May 25, 2012

DWQ Project # 12 0478
 New Hanover County

Subject Property: **Global Laser Enrichment (GLE) Commercial Facility, Castle Hayne
 Approval of 401 Water Quality Certification with Additional Conditions**

GLE Commerical Facility

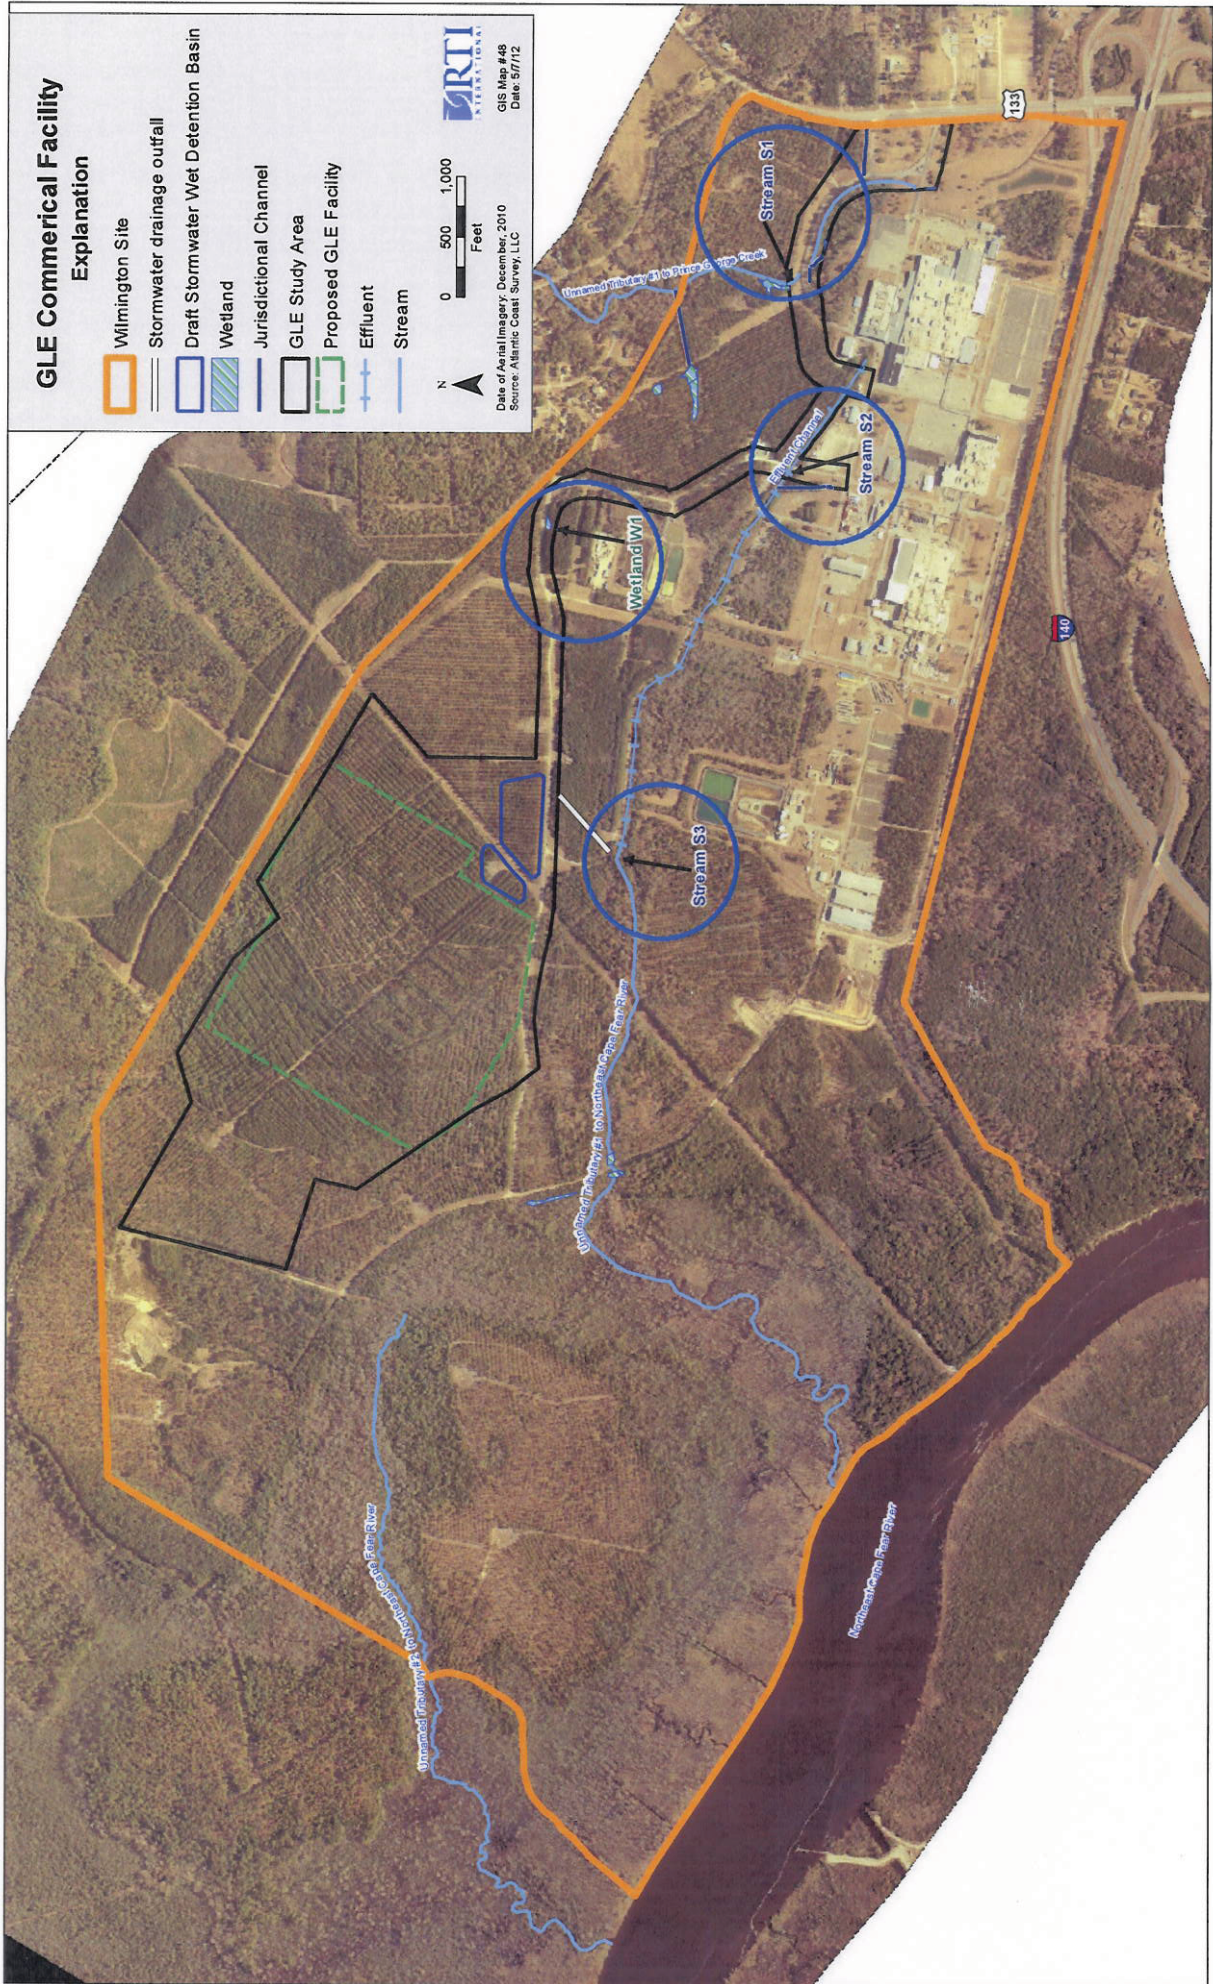
Amount Approved (Units)	Plan Location or Reference
Wetlands Small Basin	(2807 sq ft) 0.06 acres	GLE Commercial Facility Explanation aerial (attached)
Stream Stream S1(permanent) Stream S2 (permanent) Stream S3 (temporary)	130 linear feet 28 linear feet 56 linear feet	GLE Commercial Facility Explanation aerial (attached)
Open Water	N/A

The following impacts are hereby approved as long as all of the other specific and general conditions of this Certification (or Isolated Wetland Permit) are met. No other impacts are approved including incidental impacts:
